# Access Compliance Report

## Public Rights-of-Way

### (Curb Ramps)

Intersection ID: 11847	Main Street: E_9TH_ST	Cross Street: N_TRYON_ST	Location: S
ADA ID: 9713B1F90600	Ramp Type: Perp	Initial Pass/Fail: Fail	Overall Compliance: No
			Severity Score: 13.75

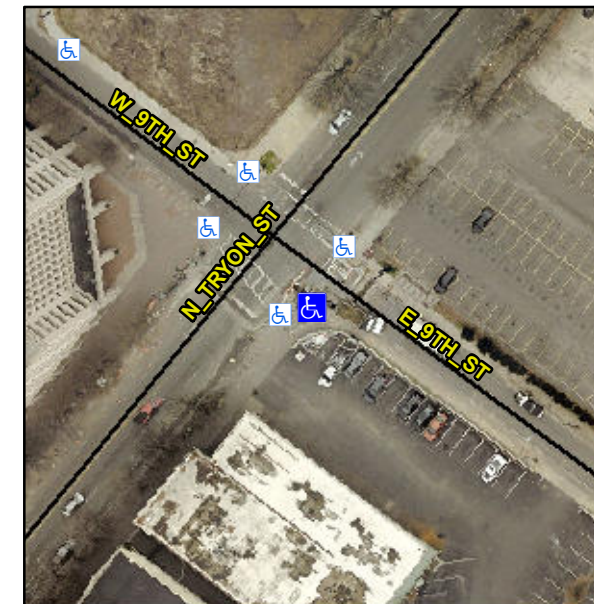
**R304.2.2, R304.5.3**

Compliance	Description	Data	Compliance	Description	Data
N/A	Ramp Length (in)	63.0	No	Ramp Slope (%)	9.6
Yes	Ramp Width (in)	48.0	No	Ramp XSlope (%)	2.2
N/A	Flare Type LT	N/A	N/A	Flare Type RT	N/A
N/A	Flare Slope LT (%)	N/A	N/A	Flare Slope RT (%)	N/A
N/A	Flare Traversable LT?	N/A	N/A	Flare Traversable RT?	N/A
N/A	Landing Length (in)	N/A	N/A	DWS Provided?	N/A
N/A	Landing Width (in)	N/A	N/A	DWS Contrast?	N/A
N/A	Landing Slope (%)	N/A	N/A	DWS Length (in)	N/A
N/A	Landing X Slope (%)	N/A	N/A	DWS Full Width?	N/A
N/A	Landing Curb? (Y/N)	N/A	N/A	DWS Offset (in)	N/A
N/A	Shared Landing?	N/A			
N/A	Gutter Ponding?	N/A	N/A	Gutter Slope (%)	N/A
N/A	Gutter Lip Ht (in)	N/A	N/A	Gutter X Slope (%)	N/A
N/A	Painted X Walk1?	No	N/A	Painted X Walk2?	N/A
	X Walk 1 Direction	To NE		X Walk 2 Direction	N/A
N/A	X Walk 1 Width (in)	N/A	N/A	X Walk 2 Width (in)	N/A
	X Walk 1 Slope (%)	5.1		X Walk 2 Slope (%)	N/A
	X Walk 1 X Slope (%)	1.6		X Walk 2 X Slope (%)	N/A

**Remove & Replace Entire Ramp.**
